# ARCHITECT RESPONSE LETTER - 1<sup>st</sup> COMMENTS

RE: 46-DR-2019  
Storage at McDowell  
K2854 (Key Code)

# ARCHITECTS RESPONSE LETTER

Storage at McDowell

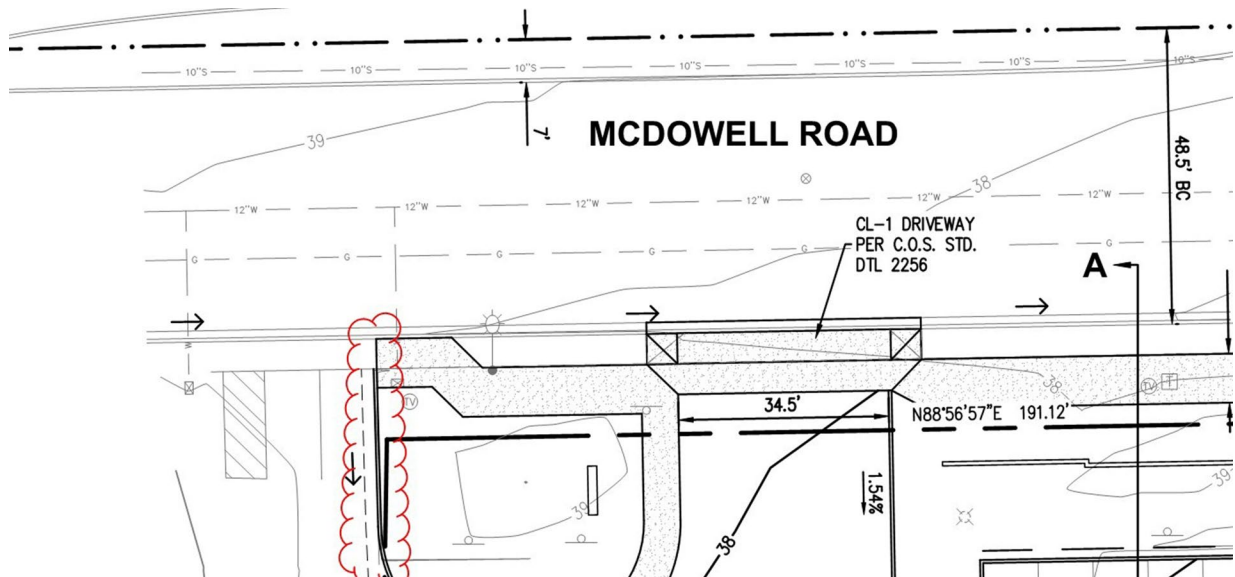
4. Per Z.O.Sec.10.602.A.3, there should be a 10-foot-wide landscape buffer between the subject development and residential districts (including any residential portions of Planned Community P-C, which would be to the east). Please update the site plan to show a 10-foot-wide landscape buffer along entire east boundary of the site that abuts the apartments in the Papago Plaza redevelopment. The 10-foot-wide landscape buffer should span the entire east property line. (However, landscape walls may remain in the 10' buffer.) There should be 10 feet of landscaping between the parking lot and the east property line as well as 10 feet of landscaping between the east property line and the new building.

The proposed development also abuts residential to the south. Instead of a 10-foot-wide landscape buffer along the new south property line, please utilize a 6-foot-tall screen wall that will match the new screen wall being built on the southern property line of the Papago Plaza site. The site plan should be revised so the new screen wall is on the southern property line after the 12 foot alley dedication. The site plan should note that the wall will match the Papago Plaza wall in color and materials.

**EASTERN SETBACK (INCL. PARKING) INCREASED TO 10'. REF SD-1**

**SITE PLAN INDICATES 6' WALL TO MATCH ADJACENT WALL (MATERIALS & COLOR) AND IS RELOCATED TO THE 12' ALLEY DEDICATION**

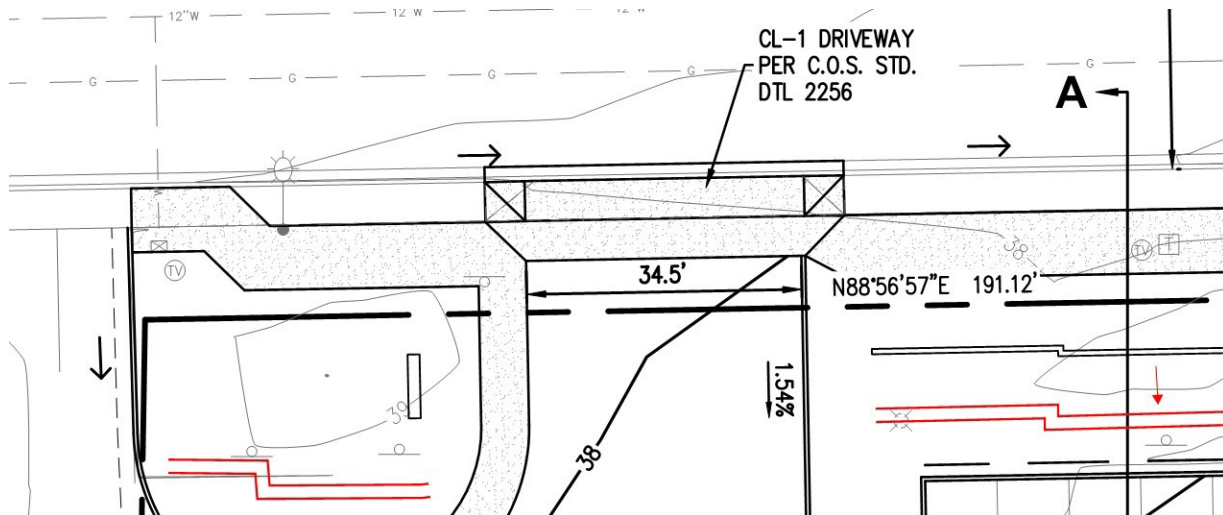
24. Please update the site plan so that the six-foot-wide on-site pedestrian sidewalk is completely clear and unobstructed by parking overhangs.

**DIMENSIONS PROVIDED ON SITE PLAN TO COMPLY WITH COMMENT**

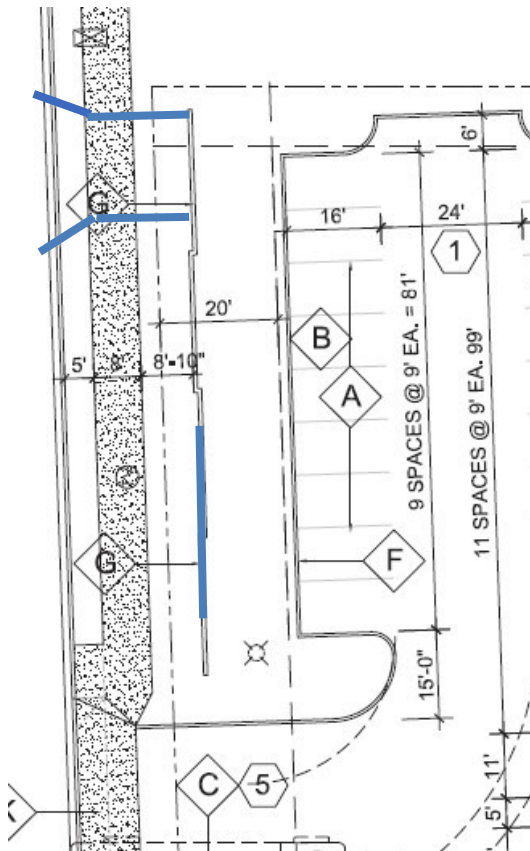
8. Per Z.O.Sec.7.600.A.4.a., at the new southern property line of the parcel, the maximum amount of light trespass is limited to 0.3 foot-candles due to the residential to the south. The photometrics plan is showing values over 0.3. Please update lighting accordingly.

**MEETING w/ K. POSLER, G. BLOEMBERG, T. CURTIS, J. ELSON, G. BELL, G. BELL III & S. STANEK @ City of Scottsdale – FOOT-CANDLE VALUES @ NEIGHBORHOOD PROPERTY LINES LESS THAN 0.3**

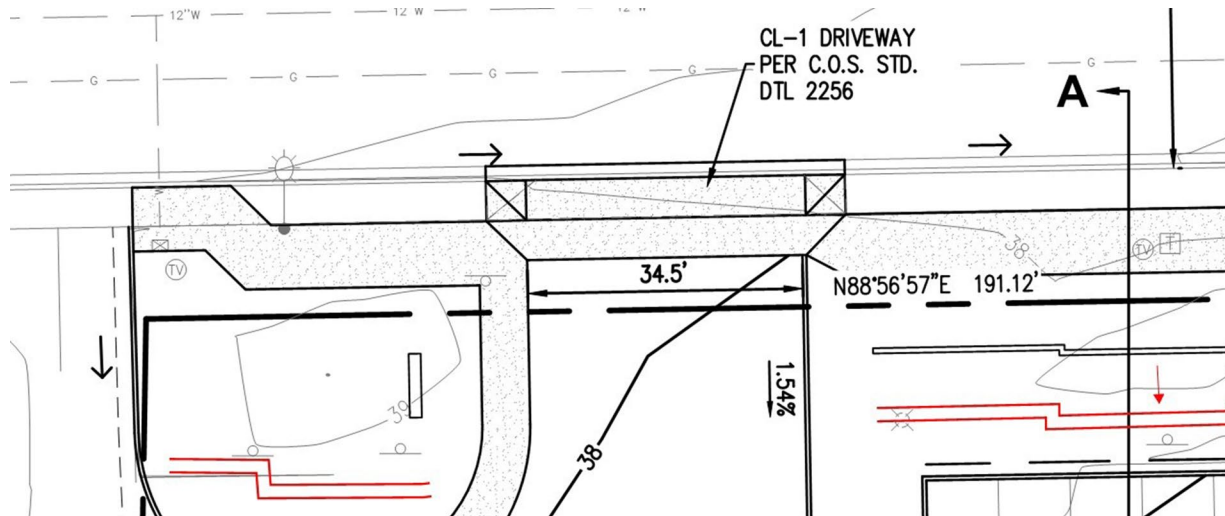
14. Based on the Commercial Design Guidelines, please remove the false front storage display windows along the north and west building elevations. These false front storage display windows act as signage and brand identity which should be avoided per the guidelines. They also act as beacons of light when illuminated in the evening. The Commercial Design Guidelines state that lighting should be used to highlight special features at a pedestrian level only and avoid lighting up large portions of the building. Please revise the elevations and floor plan accordingly to eliminate that display area.

**DISCUSSED & RESOLVED @ MEETING w/ K. POSLER, G. BLOEMBERG, T. CURTIS,  
J. ELSON, G. BELL, G. BELL III & S. STANEK @ City of Scottsdale**

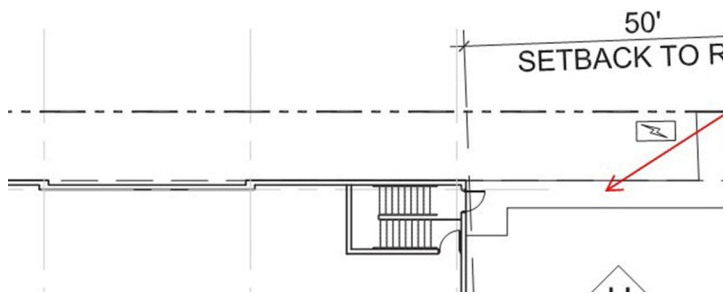
24. Please remove any monument signage call outs as that is a separate review.

**MONUMENTS SIGN REMOVED FROM SITE PLAN**

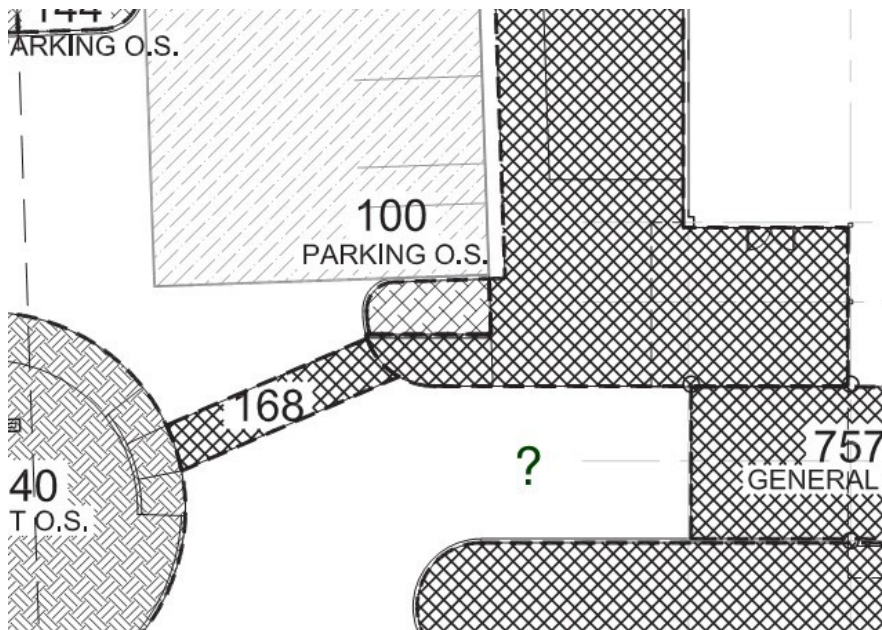
27. Is the area below a drop off/parking area? Please explain. It should be accounted for in the required parking lot and parking lot landscaping calculations.

**MEETING w/ K. POSLER, G. BLOEMBERG, T. CURTIS, J. ELSON, G. BELL, G. BELL III & S. STANEK @ City of Scottsdale – FUNCTION OF LOBBY/DROP-OFF @ CANOPY DISCUSSED & AGREED ON**

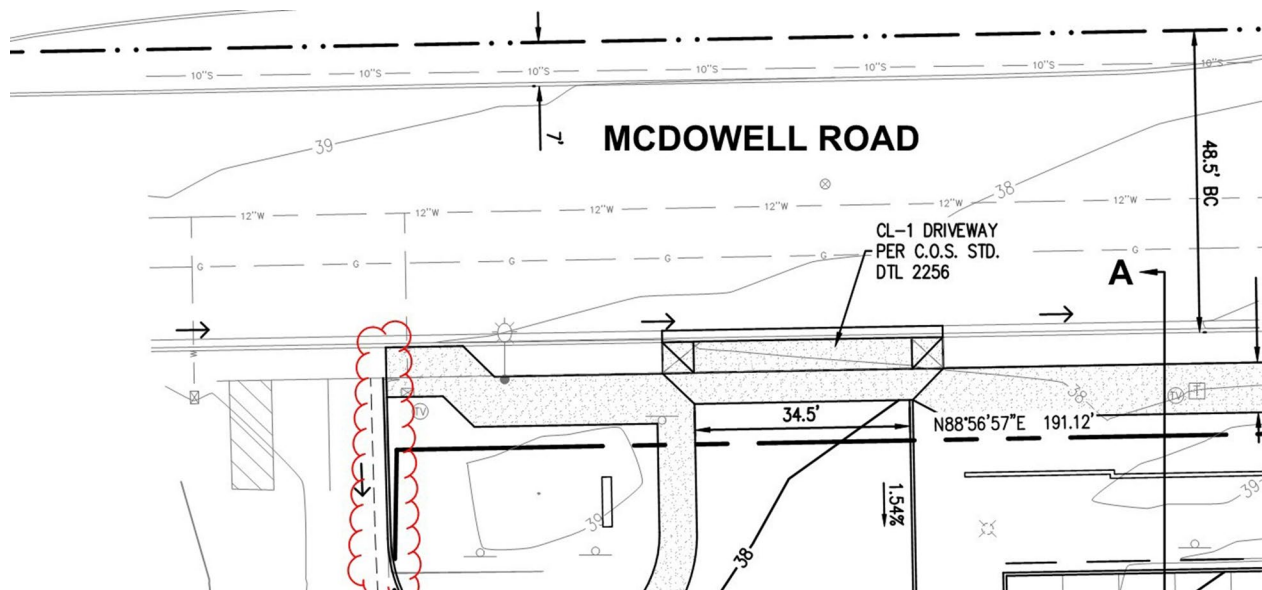
28. The proposed site plan and grading and drainage plan show improvements being done on the western parcel. Revise the site plan and grading plan so work is completed on the subject site. See below.

#### **CIVIL & SITE PLAN REVISED**
